INDEPENDENT EXPERT'S REVIEW OF INITIAL DEISION IN ANNUAL RATE PROCEEDINGS (ELECTRICITY)

Public Utilities Commission (BELIZE)

Belize Electricity Limied

08 September 2020

Figure 1: Comparison between projected energy mix for CFE, solar, and fossil resources between BEL and PUC.

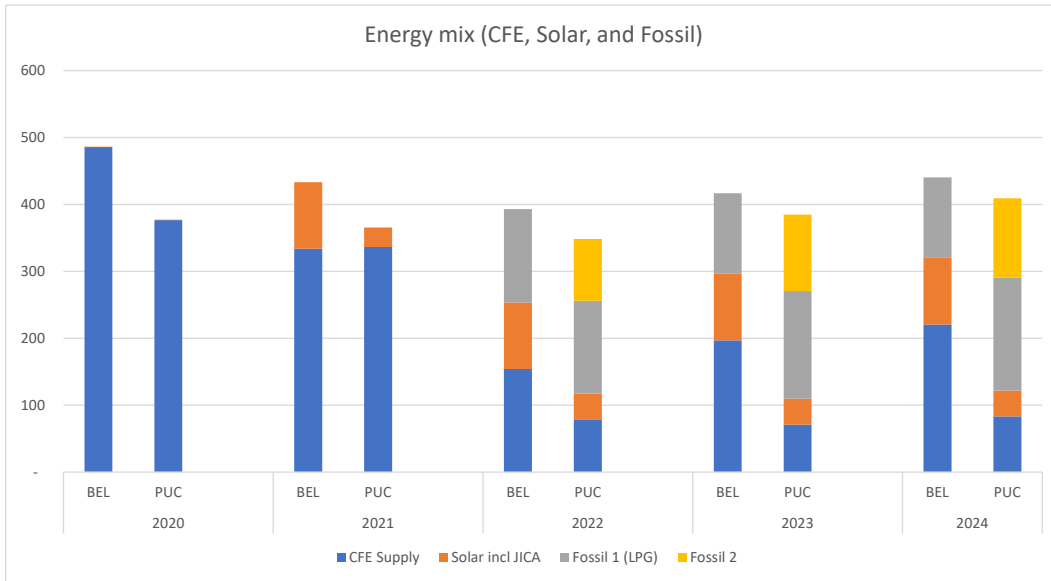
BEL's observation that CFE quantities have been increased do not seem to be correct. As can be seen in Figure 1, PUC's forecasts for CFE quantities are in fact lower than BEL's. This objection is therefore considered to be invalid.

BEL’s objection that the PUC has reduced quantities from solar production and increased those from gaseous fuel generation on the other hand is correct. The PUC overall strategy seems to have been to reduce supply from CFE and solar and replace this by hydro and fossil. Also refer to Table 1 where it can be seen that CFE and solar have been reduced by a total of $(-12.1 - 6.9 = -19\%)$ while this has been offset by hydro/IPPs $(+ 8.1\%)$ and fossil $(2.4 + 8.8 = 11.2\%)$. No arguments have been presented by the PUC on the specific choice for this different energy mix, but it seems to be driven by the view of the PUC that (1) there will be no further PV introduced due to the 20 MW limitation, and (2) additional fossil generation capacity will be installed.

Figure 2: Trend in sales by BEL 2020 versus 2019.

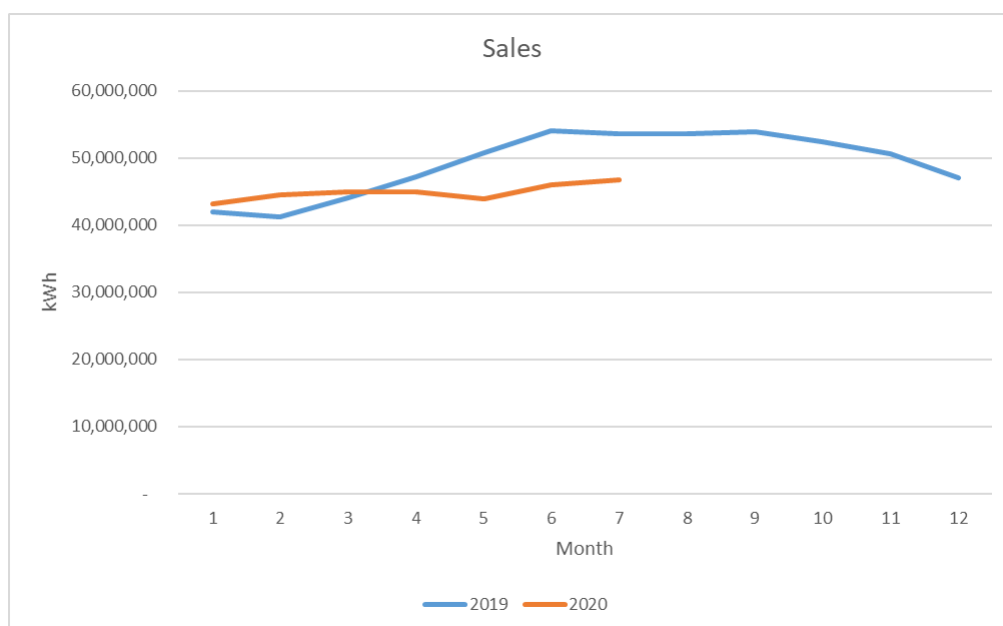
At the same time, it should be noted that at the time of the development of these forecasts (before the COVID-19 situation), fuel prices were at higher levels. These prices have dropped significantly due to the reduction in demand. In this regard, it is very unlikely that the assumed prices for fossil generation as shown in Table 2 will still be valid.

Furthermore, it is also to be questioned whether the COP forecasts by either BEL or the PUC will still be valid, given that the demand in the BEL system has dropped significantly. Sales data from BEL show that there has been a significant drop since March due to the COVID-19 pandemic (see Figure 2). In the period April till July 2020, the level of sales has been 11.5% less than in the corresponding period in 2019. This will certainly also have a major impact on the energy mix and hence the COP.
